Access Compliance Report

Public Rights-of-Way

Intersection ID: 13760	Main Street: EUCLID_AV	Cross Street: TEMPLETON_AV	Location: S
ADA ID: EAD5C9D77613	Ramp Type: Directional1	Initial Pass/Fail: Fail	Overall Compliance: No
Codes/Mitigation Info/Possible Solution		Field Measurements/Component Compliance	
Severity Score: 31.25

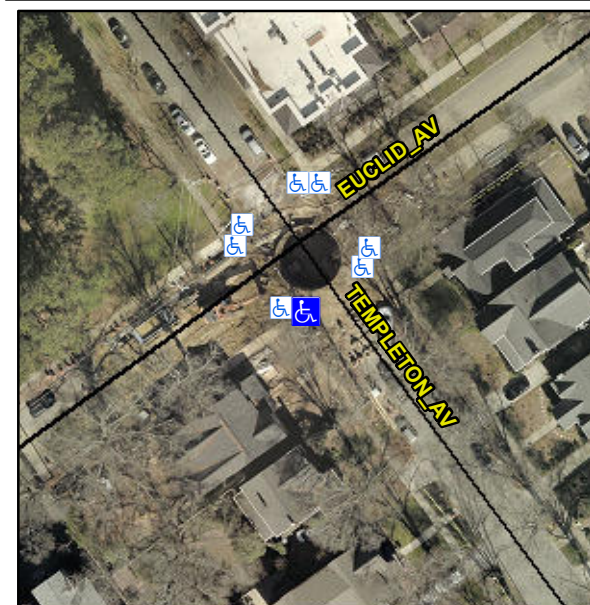
R304.5.1, R304.2.2, R304.5.3

Compliance	Description	Data	Compliance	Description	Data
N/A	Ramp Length (in)	18.0	N/A	Grade Break?	N/A
No	Ramp Width (in)	32.0	N/A	Grade Break Slope (%)	0.0
No	Ramp Slope (%)	9.1	N/A	Grade Break XSlope (%)	0.0
No	Ramp XSlope (%)	3.1			
N/A	Flare Type LT	N/A	N/A	Flare Type RT	N/A
N/A	Flare Slope LT (%)	N/A	N/A	Flare Slope RT (%)	0.0
N/A	Flare Traversable LT?	N/A	N/A	Flare Traversable RT?	N/A
N/A	Landing Length (in)	0.0	N/A	DWS Provided?	N/A
N/A	Landing Width (in)	0.0	N/A	DWS Contrast?	N/A
N/A	Landing Slope (%)	0.0	N/A	DWS Length (in)	N/A
N/A	Landing X Slope (%)	0.0	N/A	DWS Full Width?	N/A
N/A	Landing Curb? (Y/N)	N/A	N/A	DWS Offset LT (in)	N/A
N/A	Shared Landing?	N/A	N/A	DWS Offset RT (in)	N/A
N/A	Gutter Ponding?	0.0	N/A	Gutter Slope (%)	N/A
N/A	Gutter Lip Ht (in)	0.0	N/A	Gutter X Slope (%)	N/A
N/A	Painted X Walk1?	No		Road Slope (%)	3.6
	X Walk 1 Direction	To NE		Road X Slope (%)	1.5
	X Walk 1 Width (in)	N/A		Clear Space?	N/A

X Walk 1 Slope (%)	3.6	N/A	Clear Space to XWalk (in)	N/A
	X Walk 1 X Slope (%)	1.5	N/A	Storm Grate/Utility Hazard?	N/A
N/A	Ramp inside XWalk1?	N/A		Storm Grate/Utility Type	
N/A	Any Obstructions?	N/A			N/A
	Obstruction Type		Yes	Surface Condition? (G/P)	Good
			N/A	Curb Slope (%)	9.9

Remove & Replace Entire Ramp.
